CHANGE ORDER

WILLIAMSON COUNTY JAIL KITCHEN & PLUMBING REMODEL

Change Order No:

PCO #37r1 - SPT Kitchen Credit & Addt Connection

As-Bid Takeoff Info

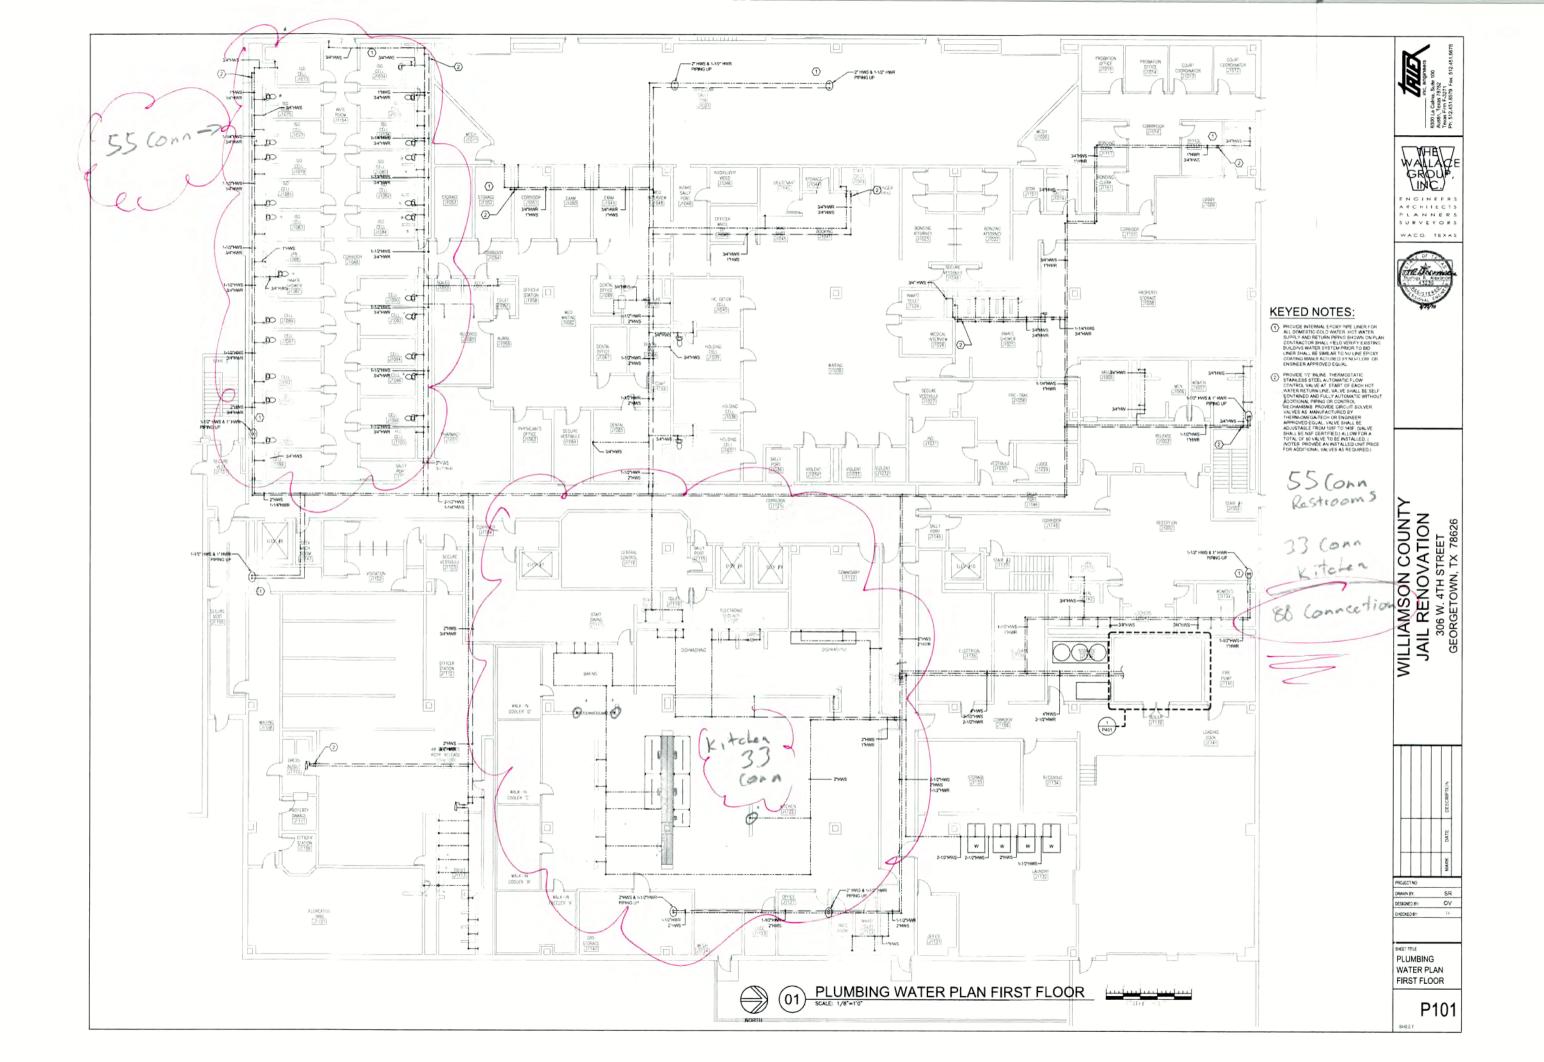
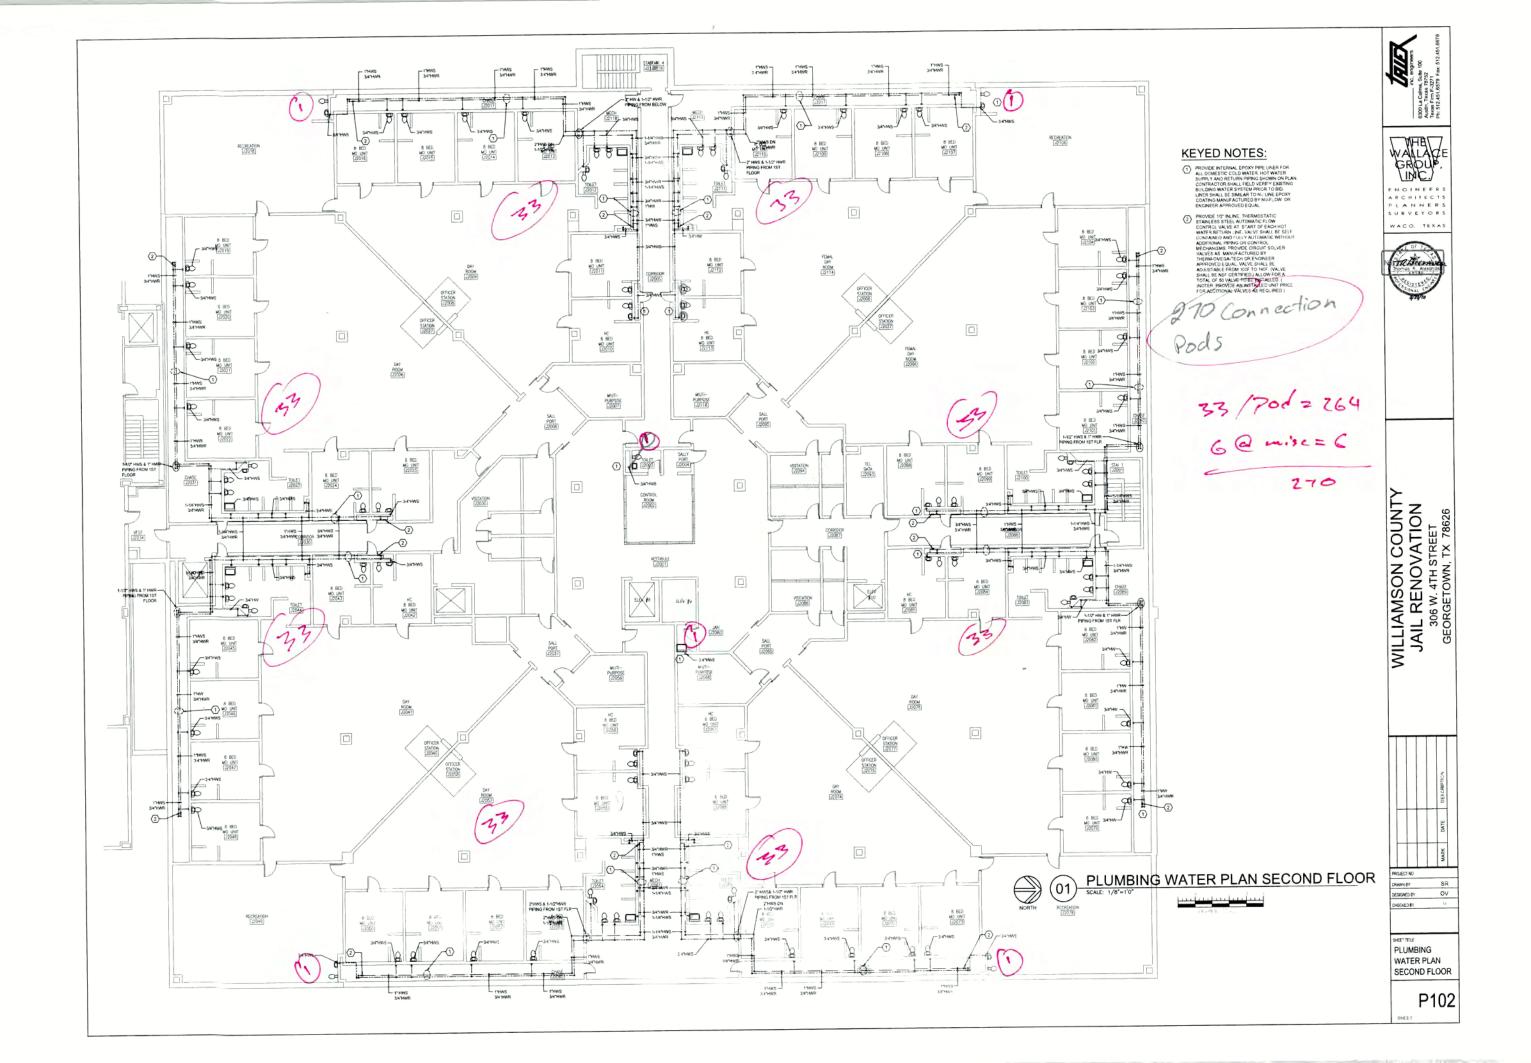
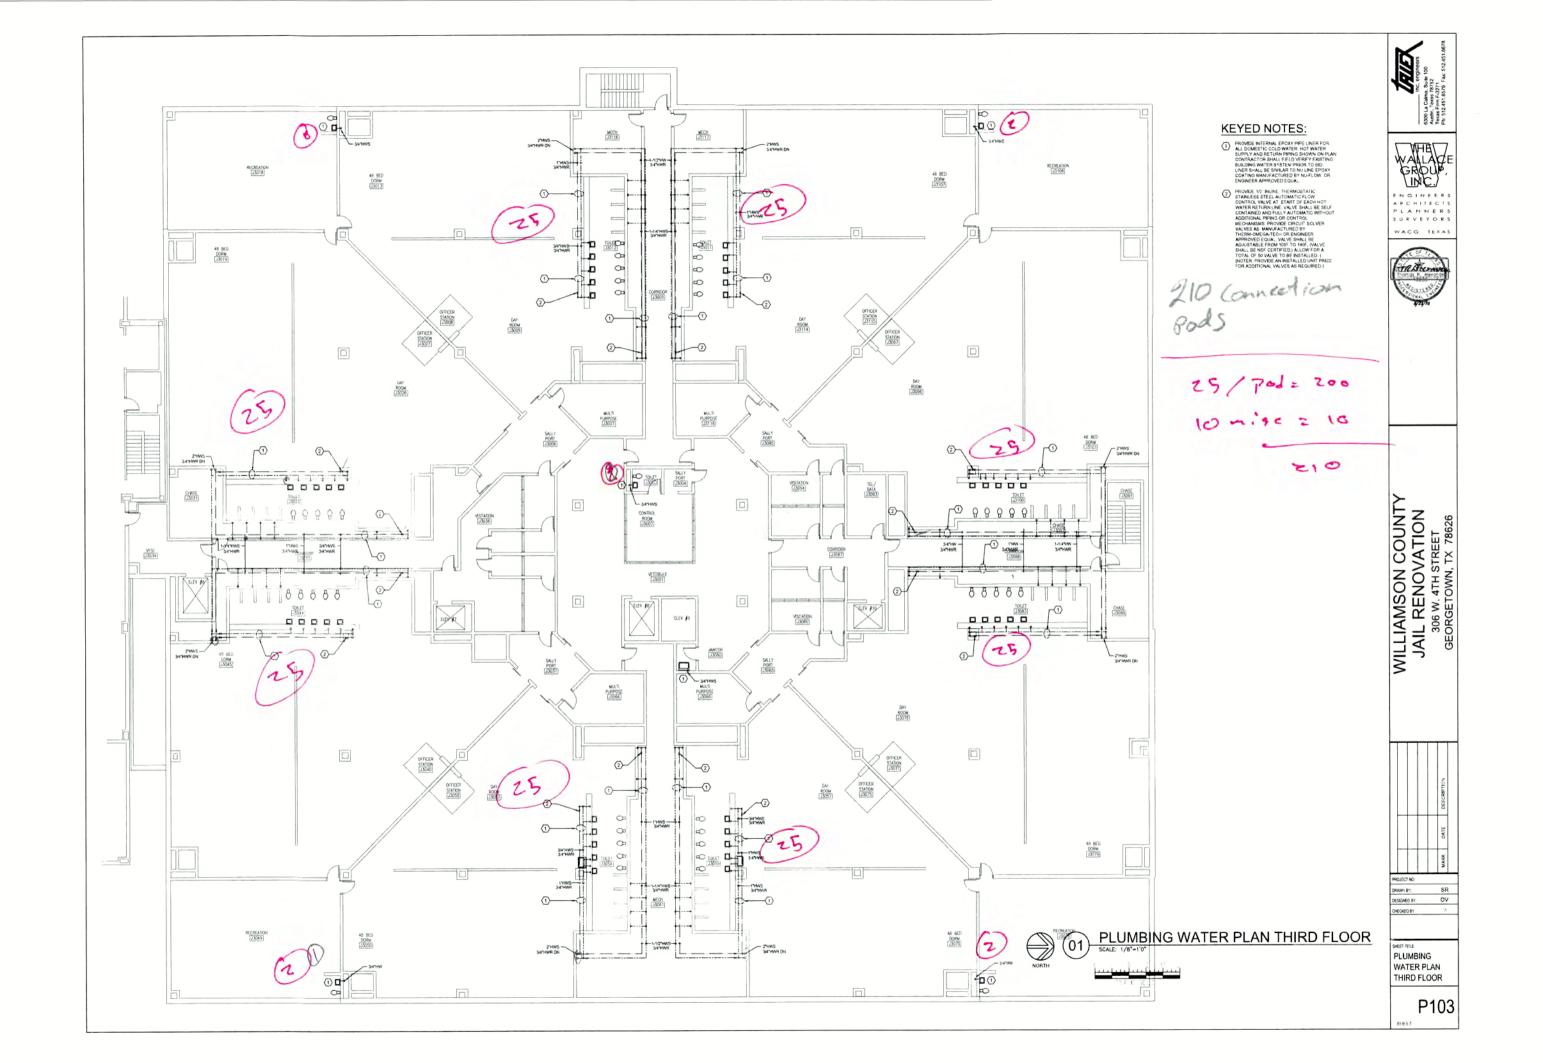
Per the attached drawings we ended up shooting (735) connections over and above the (568) connections anticipated and listed in our original proposal. Connections are defined as locations where the epoxy is to be applied through/to and can vary depending on layout, system remodels, valve locations, diameter changes, distances and are dependent on-site and environmental conditions.
